# 2014 - 2016 Corvette: Service Bulletin: #17-NA-278: Convertible Top Creak or Snap Noise While Driving

## #17-NA-278: Convertible Top Creak or Snap Noise While Driving - (Aug 29, 2017)

<b>Subject:</b>				Convertible Top Creak or Snap Noise While Driving			
Brand:	Model:	Model Year:		VIN:		Engine:	Transmission:
		from	to	from	to		
Chevrolet	Corvette Convertible	2014	2016			All	All

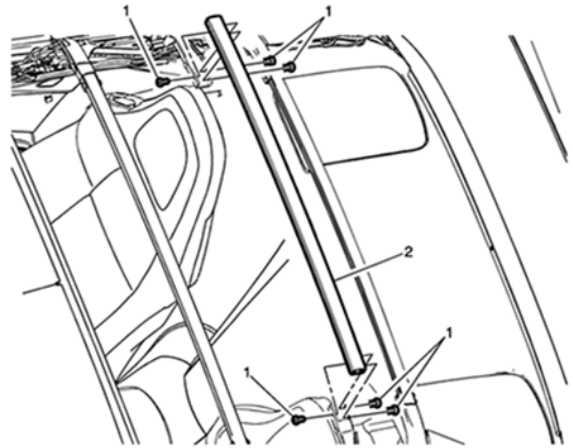
The cause of the condition may be that the fasteners (1) at the ends of the #3 Bow (2) may have lost torque.

Following the Service Procedure below, remove the original smaller screws and install the new larger M6 screws referenced in the Part Table.

1. Starting on either side, replace the current M5 retaining screws with the new M6 self threading screws.

Tighten the screws to 3 Y (27 lb in).
